FIELD SERVICE BULLETIN

FSB Number: LVCCFSB2005-290
 Authors: Darwin Garcia
 Date: September 15, 2005
 Total No. of Pages: 2
 Subject: **V3 CLI FPC Inserting Deflective**
 Model Affected: **V3**
 Level of Repair: 3 & 4

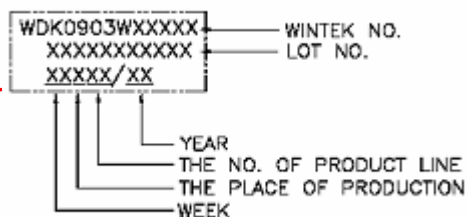
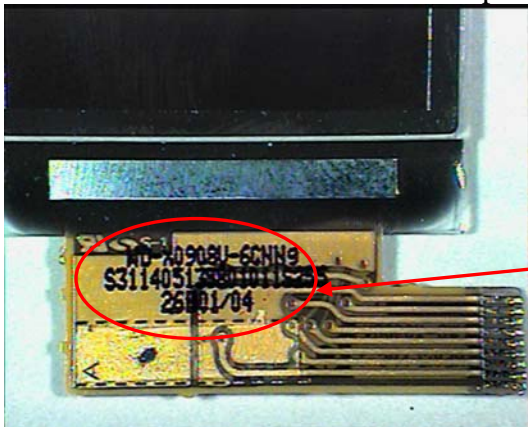
Service has been made aware of a V3 sub-CLI from Sanyo-Epson FPC insert issue causing “No CLI Display” complaints.

The root cause was determined to be the protective board of FPC on the Sub-CLI due to insufficient glue.

Supplier has changed material of glue to a more stronger adhesive. The corrective action was implemented on 6/26/2005, so all CLI modules manufacture after date code 26XXX/05 has the improvement.

Date Code (3rd Row): **XXXXX/XX**
 Good Date Code: **26XXX/05 and later**
